UNITED STATES
NUCLEAR REGULATORY COMMISSION

IE Bulletin No. 80-16

POTENTIAL MISAPPLICATION OF ROSEMOUNT INC. MODELS 1151 AND 1152 PRESSURE TRANSMITTERS WITH EITHER "A" OR "D" OUTPUT CODES

IE Circular No. 80-16

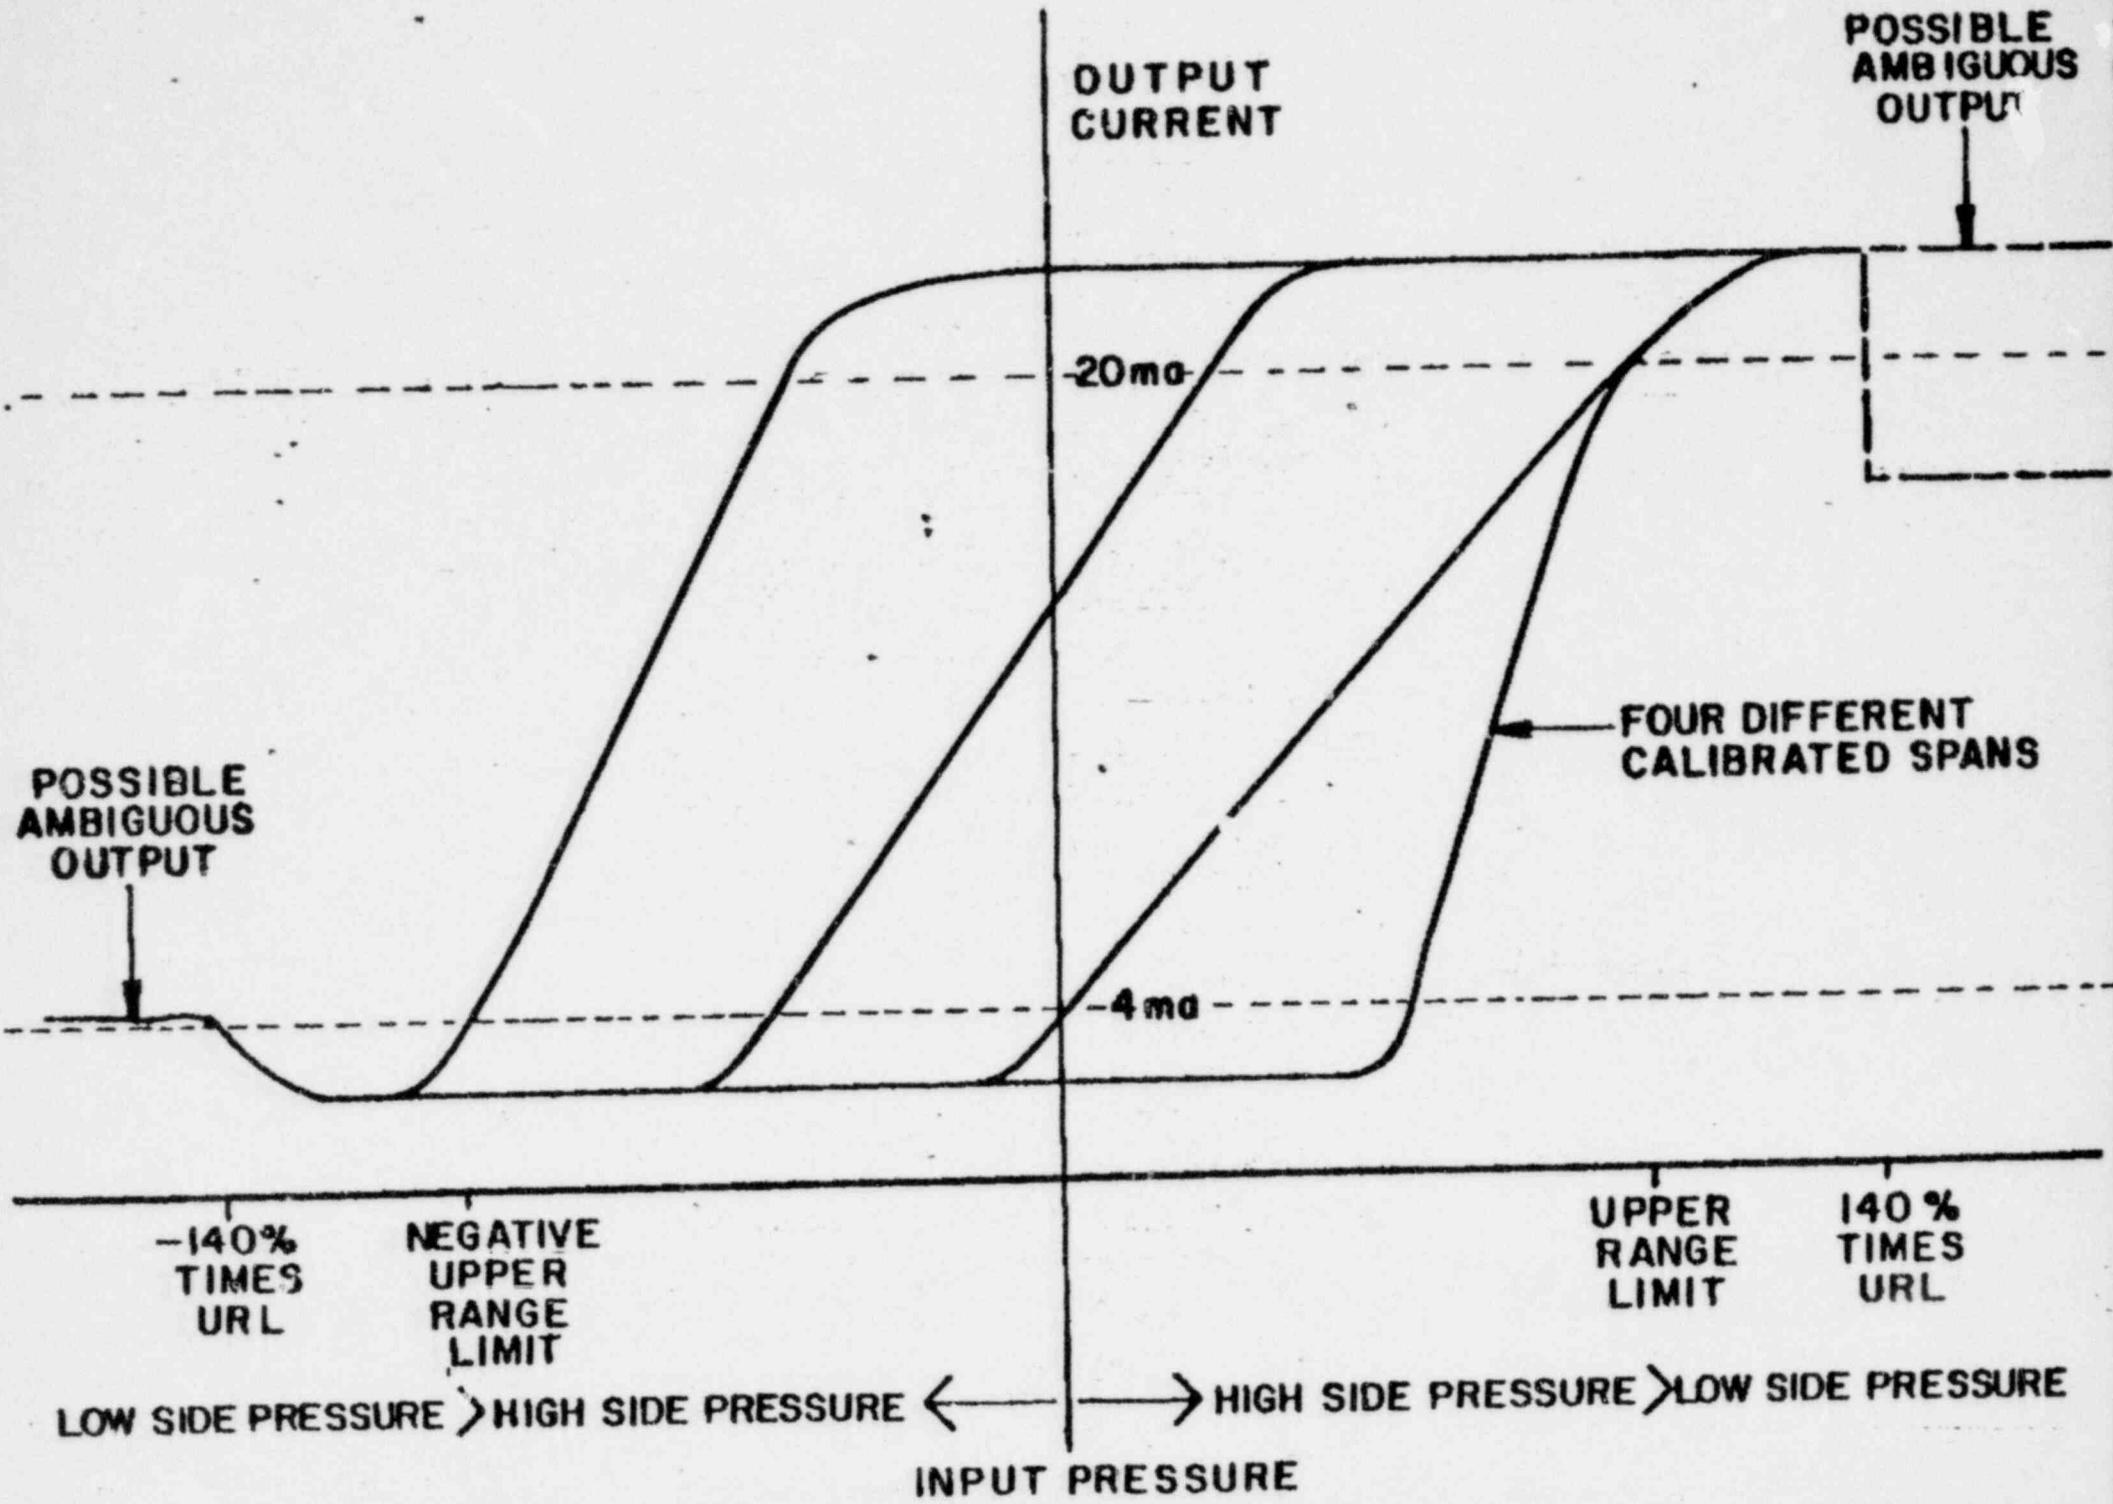
Rosemount's Model 1152 pressure transmitter provides a specified linear output of 4 to 20 mA throughout the calibrated range of operation. The transmitter output is not specified by Rosemount for pressures outside of the calibrated range of operation. It has been observed in a limited number of transmitters that an output between 4 and 20 mA can occur with certain input pressures outside of the calibrated range. These ambiguous outputs can occur in both an over pressure condition and a reverse pressure condition. Both conditions arise when the center diaphragm of the pressure sensor bottoms out against either of the fixed capacitor plates. In each case the normal capacitance signal becomes a very high capacitance signal which affects the operation of the electronic circuit.

For the over pressure condition, the effect of the high capacitance from the sensor is a modulated output on the oscillator circuit which may cause the output current of the transmitter to drop below 20 mA. In a limited sample size, the ambiguous output during this over pressure condition occurred in 5% of the transmitters at ambient conditions. Referring to the attached graph, this does not occur until the over pressure condition is $\geq 140\%$ of the upper range limit regardless of span. At that point a discontinuity can occur with the output current instantaneously decreasing to less than 20 mA. As an example of this potential applications problem, the upper range limit of a range 5 1152 differential pressure transmitter (Model 1152DP5A22) is 750"H₂O. The range of this pressure transmitter can be set from 0 to 150"H₂O. If the ambiguous output in the over pressure condition is to occur, it will occur at 140% or more of the upper range limit or, in this case, at pressures ≥ 1050 "H₂O (750"H₂O x 1.4). The transmitter than could give an output less than 20 mA at a pressure that is, in this example, seven

times (1050"H₂O + 150"H₂O) the upper range value. Note that the significant figure for use in determining the pressure above which an ambiguous output can occur is the specified upper range limit (750" H₂O in this example) not the customer selected upper range value (150"H₂O in this example).

For the reverse pressure condition, the effect of the high capacitance from the sensor is the oscillator circuit drawing more current which may cause the output current of the transmitter to exceed 4 mA. In a limited sample size, the ambiguous output during this reverse pressure condition occurred in 55% of the transmitters at ambient conditions. Referring to the attached graph, this does not occur until the reverse pressure condition exceeds 140% of the upper range limit regardless of the span. At this point the output may exceed 4 mA. As an example of this potential applications problem consider the range 5 differential transmitter in the previous paragraph. If the ambiguous output in the reverse pressure condition is to occur, it will occur at 140% or more of the upper range limit, or in this case at reversed pressures $\geq 1050"$ H₂O (750"H₂O x 1.4). The transmitter then could give an output greater than 4 mA at a pressure that is, in this example, seven times (1050" H₂O + 150" H₂O) the upper range value, but reversed. Also note that with absolute pressure units a reverse pressure is not possible since the low pressure side of the cell is evacuated. With gage units a reverse pressure is possible only if a vacuum is present on the connected part since the low pressure side of the cell is vented to ambient atmosphere. Since the maximum reverse pressure would be one atmosphere, only range 3 and 4 gage units could obtain a reverse pressure exceeding 140% of the upper range limit.

The safety system should be analyzed in view of this supplementary report to determine if a potential application problem exists and appropriate corrections to the safety system should be implemented.
